SONIC
RESTAURANT

STAFF REPORT

RE: **2312 & 2318 N. Roosevelt Blvd
(permit application # T17-8629)**

FROM: Karen DeMaria, City of Key West Urban Forestry Manager

**LANDSCAPE PLAN
& DETAILS**

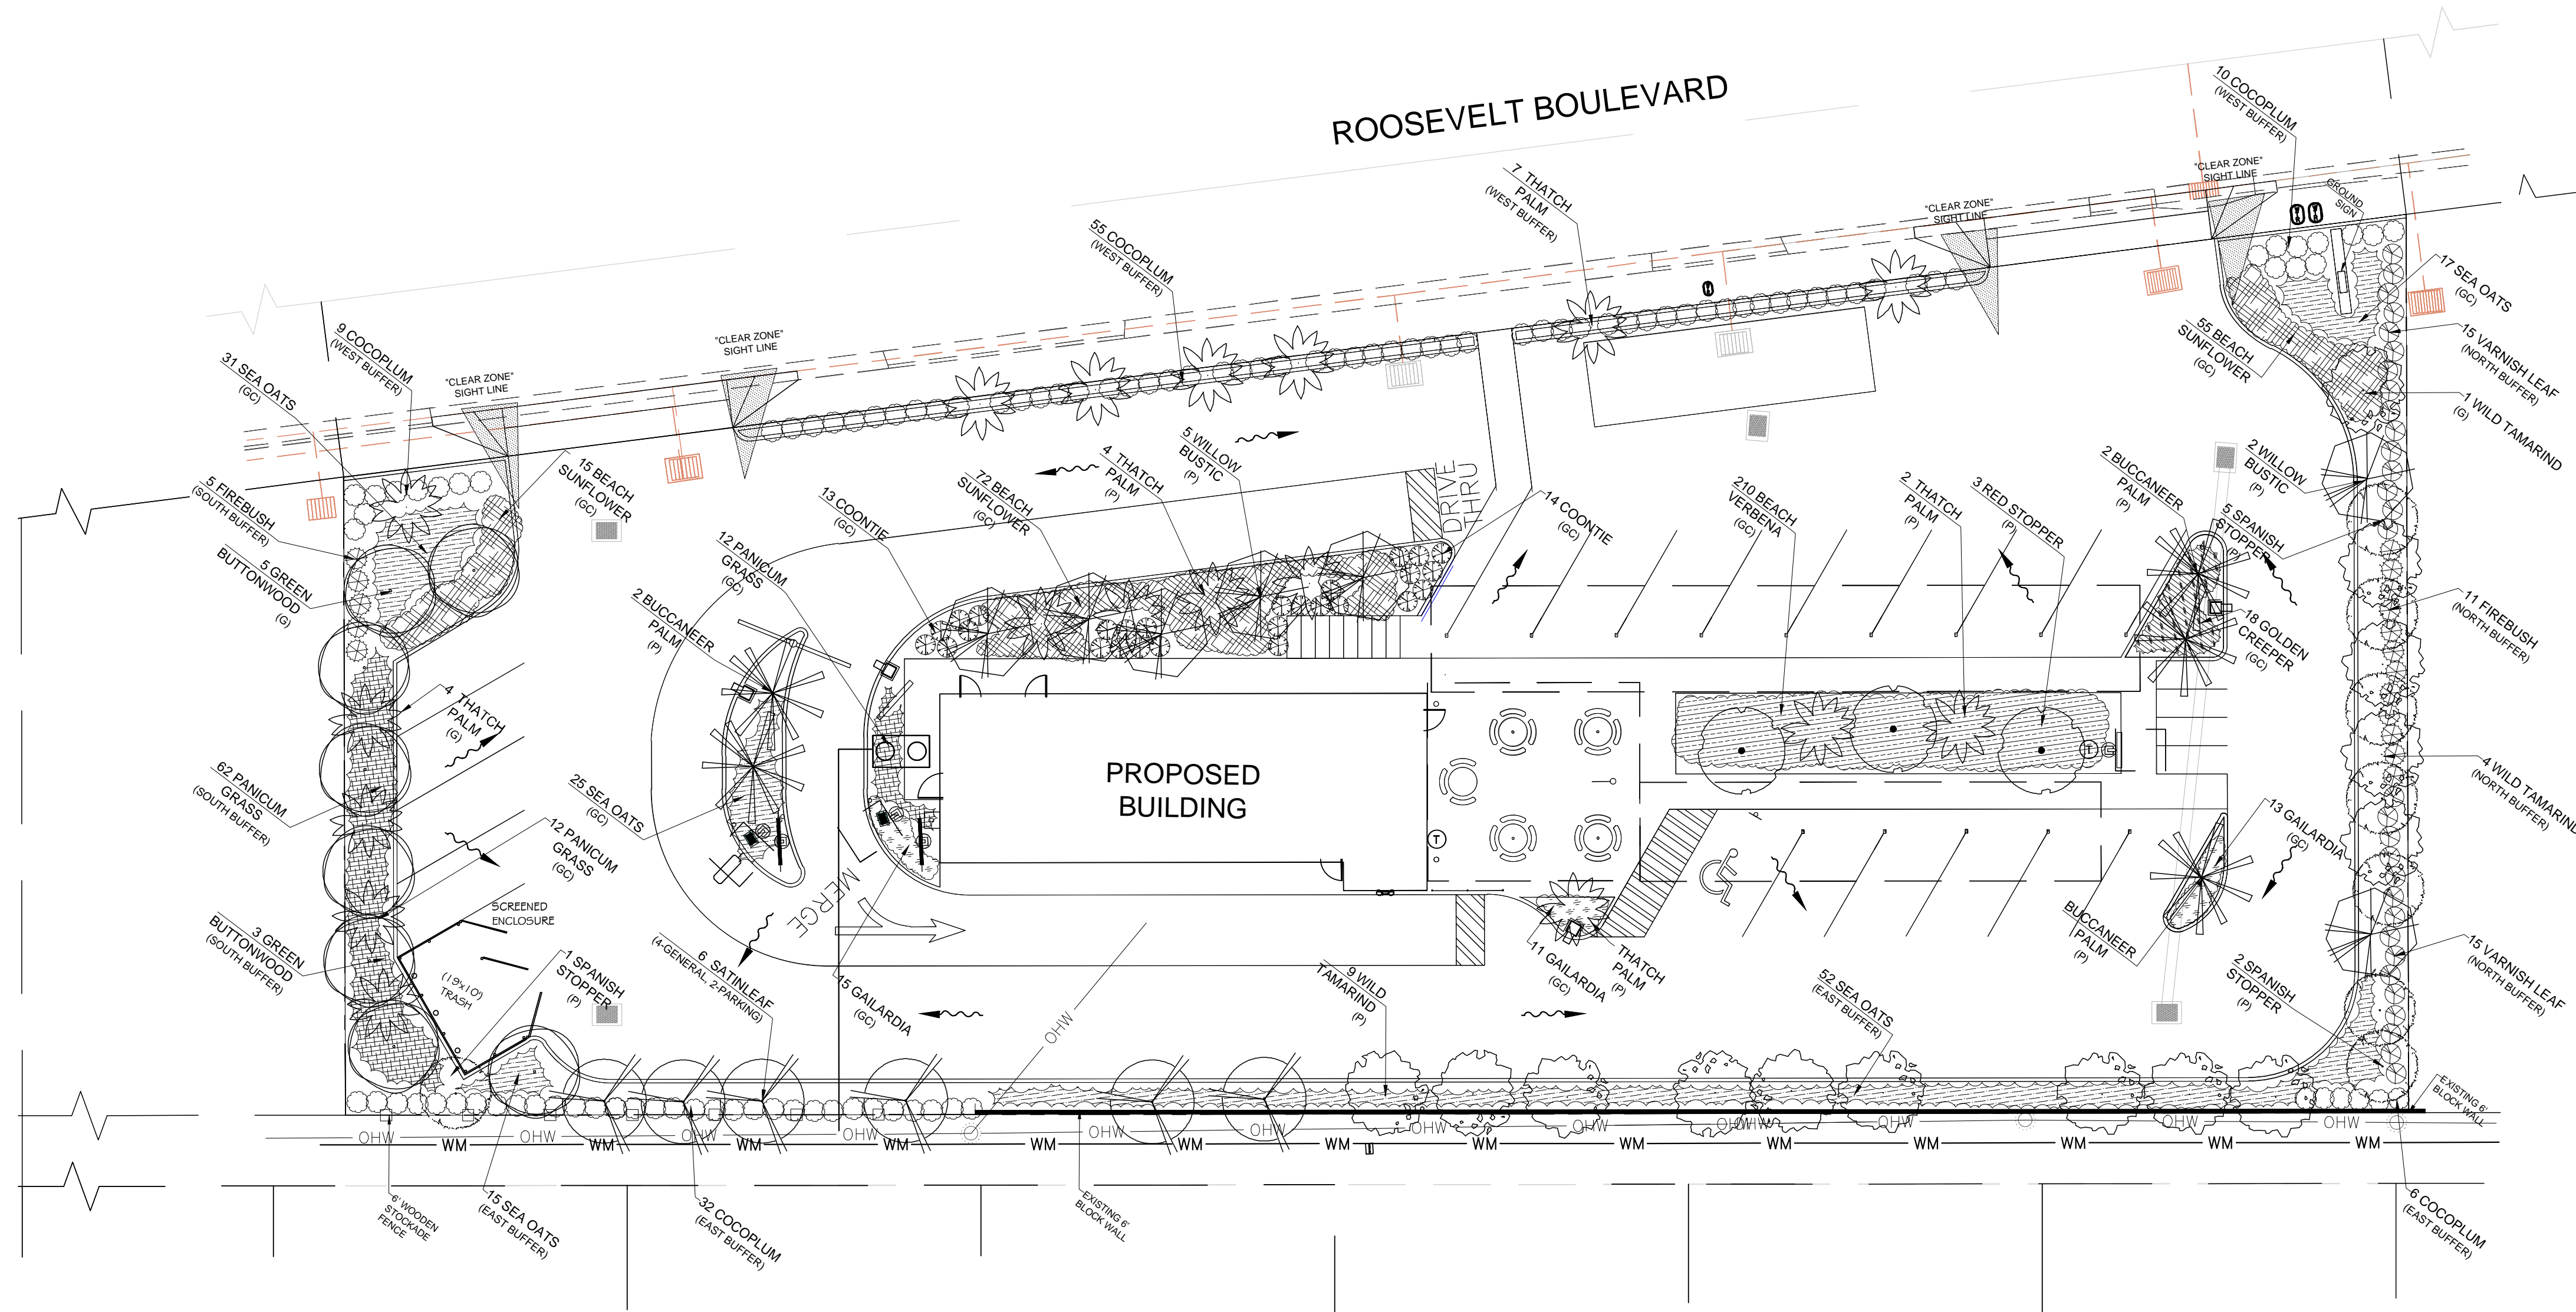
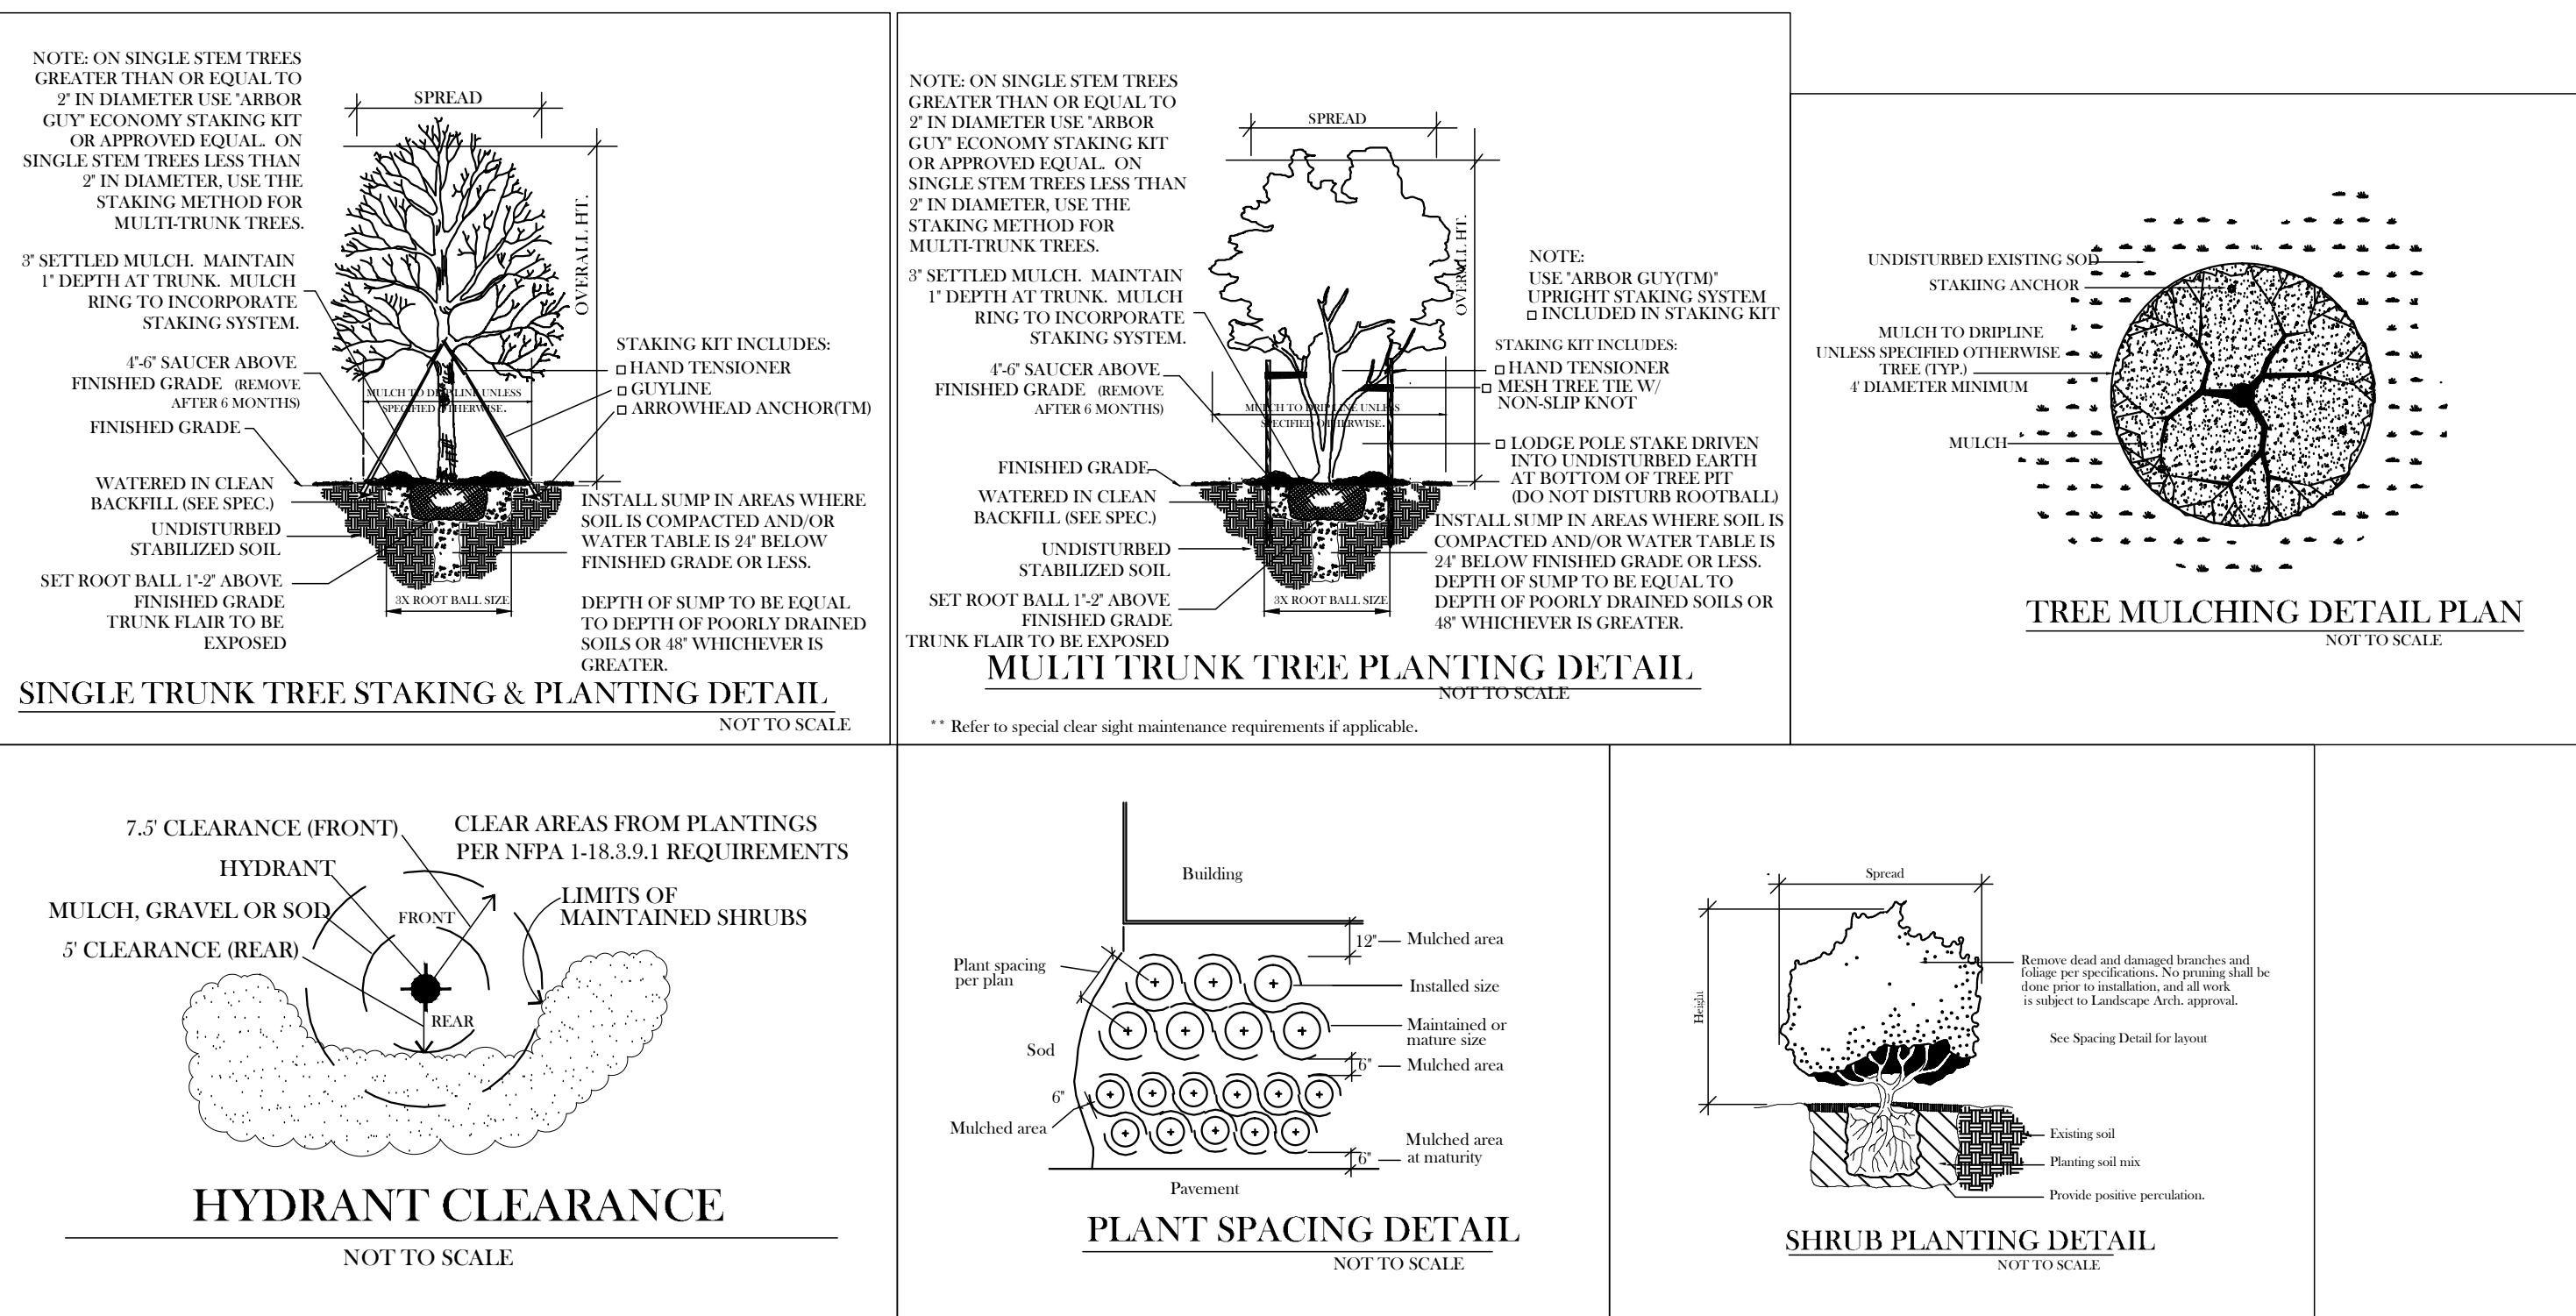
The Final Landscape Plan submitted does incorporate all the required tree removal replacements (46.3 caliper inches) and is over 70% native vegetation.

The proposed landscape plan appears to incorporate all the required replacement inches and is over 70% native and salt tolerant vegetation.

Recommendation: Recommend approval of the Final Landscape Plan with Tree Removal to include the removal of (2) Strangler Fig trees at 2318 N. Roosevelt Blvd. The approval requires the replacement of 46.3 caliper inches of native dicot and/or fruit trees from the approved list, FL#1, to be planted onsite and incorporated into the landscape plan.
